Technical Journal

ECM-P04F000, Evap System, High Pressure Purge Line

REF NO: TJ 34857.4.0	ISSUING DEPARTMENT: Technical Service	CAR MARKET: United States and Canada	
PARTNER: 3 US 7510 Volvo Car USA		ISSUE DATE: 2019-12-31	STATUS DATE: 2020-03-16
FUNC GROUP: 2340	FUNC DESC: Fuel tank, fuel lines, evaporator system	Page 1 of 5

TJ 34857

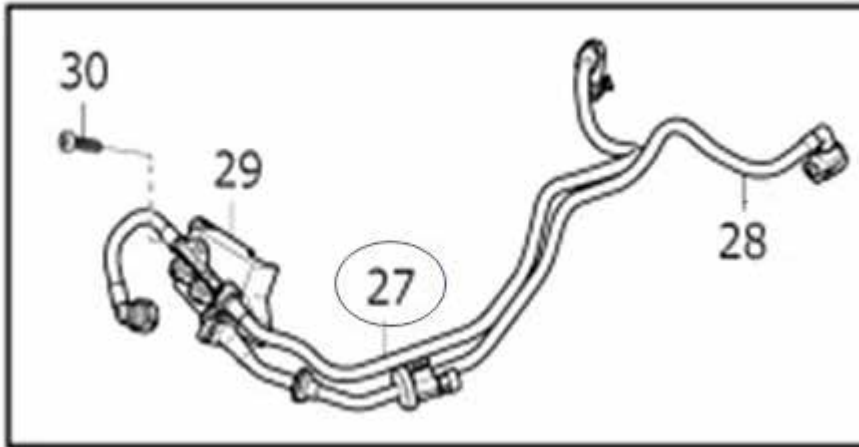
Replace only evaporator pipe in position 27, see attachment TJ 34857, according to VIDA.
Check VIDA for the latest part number of the evaporator pipe.

* Due to mixed material on the market, check the stamp on the Evaporator valve on the Evaporator pipe, see attachment TJ 34857_2.

Read it like this: Day, Month, Year. Stamps/dates before 16 January 2020 is NOT okay.
